MEMORANDUM

From:	Catherine Brimble Senior Landscape Officer
Service	SDL Landscape and Trees
App No:	243087
Address:	Arborfield Green District Centre, Arborfield Green, Arborfield, Berkshire.
Proposal:	Application for submission of details to comply with the following condition of planning consent O/2014/2280 (140977) dated 02/04/2015. Condition 14 relates to hard and soft landscaping scheme (part discharge); 26 to detailed design of roads (part discharge); 27 to construction accesses; 46 to wetland features; 57 to lighting; 65 to construction environmental management plan (part discharge).
Type of Development:	
Site Visit Made:	Yes/No

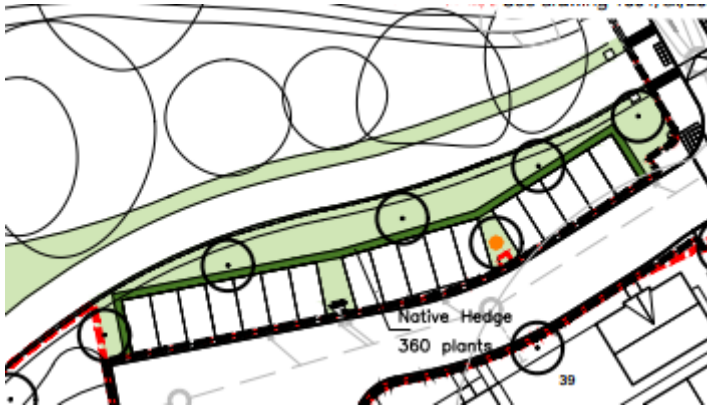
I have the following comments to make on the Linear Park Phase 2 Planting Plan:

- I can only see one bench and one litter bin on the plan. I would expect to see an additional litter bin at one of the entrances to the LEAP, and several more benches around the park to encourage less able people out into this area where they know there will be somewhere for them to rest.
- It looks as if there is some bulb planting proposed around the two picnic benches, and these will need to be indicated in the planting schedule.
- Six trees shown within the red line of the site at the western end of the Linear Park are not labelled and will need to be included. Their location is shown below.
